# Adult Community Center

## Town of Barnstable ADA Transition Plan

August 2021

Institute for Human Centered Design

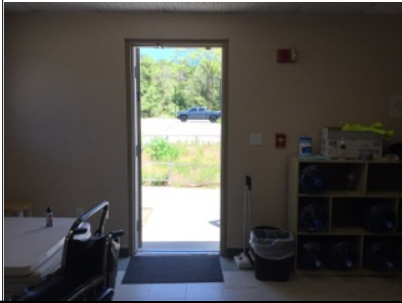
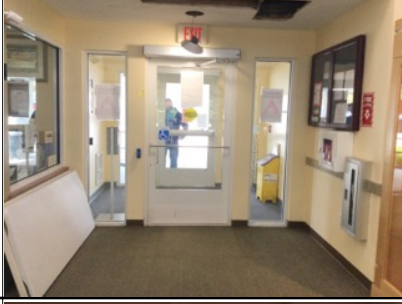
ID	Location	Floor	Room	Element	Type	Photo	Issues	Current Measure	Recommendations	Quantity	Price	Cost Estimation
<b>Approach and Entrance</b>												
<b>Exterior Access Route</b>												
1	Electric Parking Near Main Entrance	Ext.		Exterior Access Route	Exterior				Relocate EV parking space so the route to the building is not blocked if a car is parked there.	1	Labor	\$0
2	Garden	Ext.		Exterior Access Route	Walkway		Obstructed by protruding objects	8"	Relocate water hose holder so it does not protrude into the circulation path.	1	Labor	\$0
3	Upper Level Garden	Ext.		Exterior Access Route	Exterior		Surface openings > 1/2"	3.5"	Repair surface.	1	-	\$0
4	Path From Lower Level to Upper Level - Garden	Ext.		Exterior Access Route	Walkway		Cross slope > 1:50 (2.00%)	3.4%	Reduce cross slope to be no steeper than 1:50 (2.00%).	1	-	\$0
5	Path Near Upper Level From Lower Level - Garden	Ext.		Exterior Access Route	Walkway		Cross slope > 1:50 (2.00%)	8.1%	Reduce cross slope to be no steeper than 1:50 (2.00%).	1	-	\$0

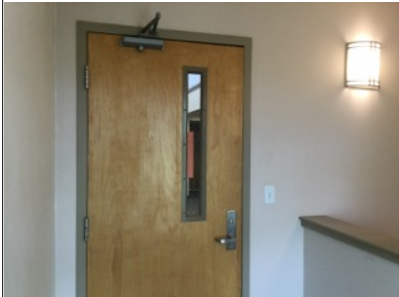
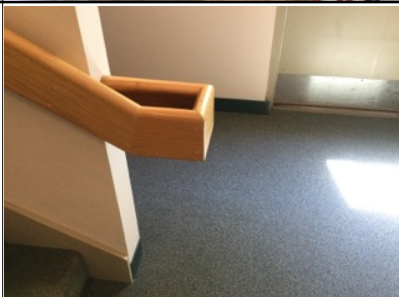
ID	Location	Floor	Room	Element	Type	Photo	Issues	Current Measure	Recommendations	Quantity	Price	Cost Estimation
<b>Off-Street Parking Lot or Garage</b>												
11	Parking Lot	Ext.		Off-Street Parking Lot or Garage	Visitor			-	Locate sign at the accessible parking space. Ensure the signs with the designation "Van Accessible" are located at the van accessible spaces. Ensure signs are mounted between 60" - 96" above the ground.  See ID #12 for additional cost.	1	Labor	\$0
12	Parking Lot	Ext.		Off-Street Parking Lot or Garage	Visitor		Identification sign not compliant	-	An identification sign is needed at each accessible parking space.	6	500	\$3000
<b>Entrance</b>												
13	Main Entrance/Exit	Ext.		Entrance	Main Entrance		International Symbol of Accessibility not provided	-	Provide a sign with the International Symbol of Accessibility (ISA).	1	346	\$346
<b>Emergency Exit</b>

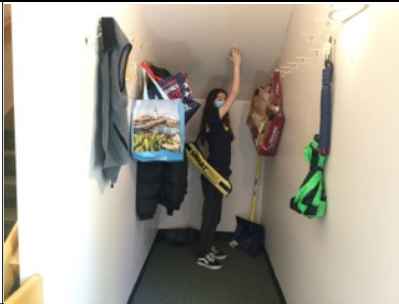
ID	Location	Floor	Room	Element	Type	Photo	Issues	Current Measure	Recommendations	Quantity	Price	Cost Estimation
16	Exit Through Storage - Multi - Purpose Room A	Ext.		Emergency Exit	N/A		Threshold > 3/4" high	4.75"	Provide a temporary ramp as needed.	1	500	\$500
<b>Access to Goods and Services</b>												
<b>Means of Egress</b>												
17	Exit Through Storage - Multi - Purpose Room A	2		Means of Egress	N/A		Tactile exit sign not provided	-	Ensure a tactile exit sign with raised characters and braille is provided at exit door. Mount sign between 48"- 60" above the finished floor located on the latch side of the door. Recommend providing a directional sign.	1	232	\$232
18	Main Entrance/Exit	2		Means of Egress	N/A		Tactile exit sign not provided Illuminated ISA symbol not provided (MAAB)	- -	Ensure a tactile exit sign with raised characters and braille is provided at exit door. Mount sign between 48"- 60" above the finished floor located on the latch side of the door. Provide an illuminated sign with the International Symbol of Accessibility.	1	432	\$432

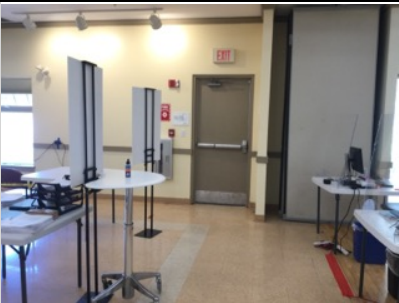
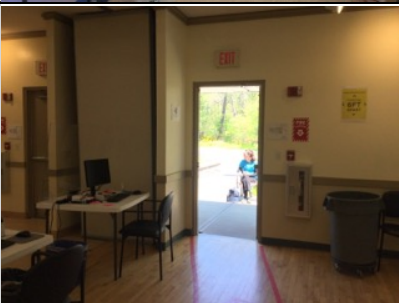
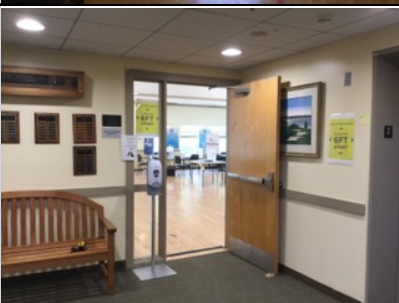
ID	Location	Floor	Room	Element	Type	Photo	Issues	Current Measure	Recommendations	Quantity	Price	Cost Estimation
21	Exit - Activity Room	1		Means of Egress	N/A		Tactile exit sign not provided Illuminated ISA symbol not provided (MAAB)	- -	Ensure a tactile exit sign with raised characters and braille is provided at exit door. Mount sign between 48"- 60" above the finished floor located on the latch side of the door. Provide an illuminated sign with the International Symbol of Accessibility.	1	432	\$432
22	Stair	2		Means of Egress	N/A		Floor level designation not provided	-	Provide a sign on the interior of the stairway enclosure indicating the floor level.	1	232	\$232
23	Exit Near Stair	1		Means of Egress	N/A		Door requires > 15 lbs. of force to open	18 lbs.	Adjust closers of exterior doors so doors do not require more than 15 pounds of force. Note: Fire doors shall have a minimum opening force allowable by the appropriate administrative authority.	1	Labor	\$0

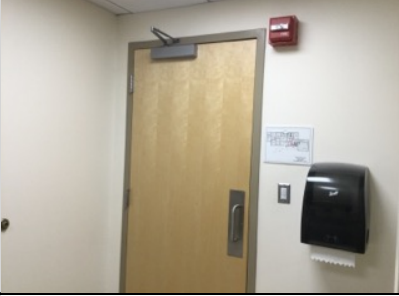
ID	Location	Floor	Room	Element	Type	Photo	Issues	Current Measure	Recommendations	Quantity	Price	Cost Estimation
26	Medical Exam Room	1		Interior Access Route	N/A		Obstructed by protruding objects	5.5"	Relocate telephone so it does not protrude into the circulation path.	1	Labor	\$0
27	Billiards Room	1		Interior Access Route	N/A		Accessible route not provided	-	Relocate chairs to maintain the accessible route to the pool sticks.	1	Labor	\$0
28	Near Stair	1		Interior Access Route	N/A		Vertical clearance < 80" above finished floor	66.5"	It may be technically infeasible to adjust the vertical clearance. Consider adding signage that says, "Low Headroom" or, "Low Ceiling".  Or relocate coat hooks and provide a cane-detectable barrier.	1	232	\$232
<b>Doors, Doorways, &amp; Gates</b>												
29	Activity Room C	2		Doors, Doorways, & Gates	Other		Maneuvering clearance(s) not provided	16.75"	Keep door open during business hours.	1	Labor	\$0

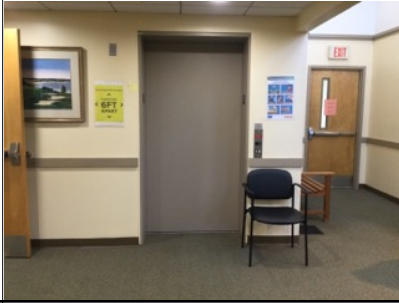
30	Lounge	2		Doors, Doorways, & Gates	Emergency Egress		Maneuvering clearance(s) not provided	-	Relocate plant to maintain the maneuvering clearance at the door.	1	Labor	\$0

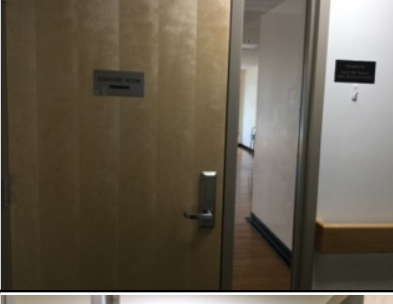
ID	Location	Floor	Room	Element	Type	Photo	Issues	Current Measure	Recommendations	Quantity	Price	Cost Estimation
36	Men's Toilet Room	2		Doors, Doorways, & Gates	Toilet Room		Door requires > 5 lbs. of force to open	15 lbs.	Adjust closers so doors do not require more than 5 pounds of force to open.	1	Labor	\$0
37	Women's Toilet Room	2		Doors, Doorways, & Gates	Toilet Room		Door requires > 5 lbs. of force to open	11 lbs.	Adjust closers so doors do not require more than 5 pounds of force to open.	1	Labor	\$0
38	Exercise Room	1		Doors, Doorways, & Gates	Emergency Egress		Door requires > 5 lbs. of force to open	20 lbs.	Adjust closers so doors do not require more than 5 pounds of force to open.	1	Labor	\$0
39	Men's Toilet Room	1		Doors, Doorways, & Gates	Toilet Room		Door requires > 5 lbs. of force to open	14 lbs.	Adjust closers so doors do not require more than 5 pounds of force to open.	1	Labor	\$0

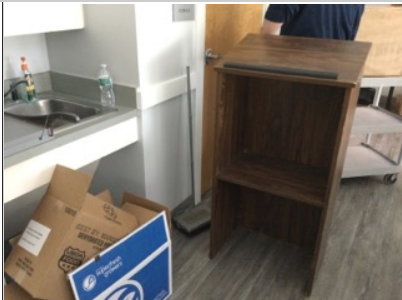
75	Women's Toilet Room	2		Toilet Compartment	Accessible Compartment		Non-compliant toilet paper dispenser	-	Relocate toilet paper so that it is 24" min. high, located under the grab bar, and between 7" and 9" from the front of the toilet.	1	256	\$256
